National Centre for Coastal Research  
(NCCR)

**Gap Analysis for Preparation of  
DPR for Kalpasar Dam**

Inception Review

Report Ref: 282702/Kal/Inc/2

Figure 2.3 Preliminary proposed cross section of the dam

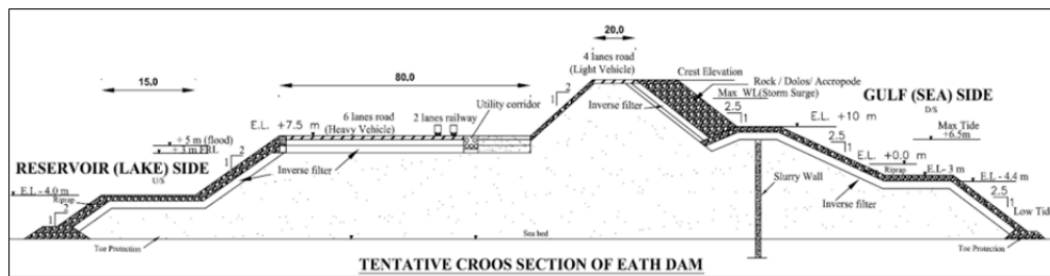
Referring to Primary Dam cross sections shown in Figure 2.3 (report 19 in Appendix 1), the currently proposed cross section for the Kalpasar dam is split into two main sections, both of a typical breakwater construction with a cement-bentonite cut off wall.

The dam typical section schematics provided show a number of components which may have limited design life incompatible with a major dam.
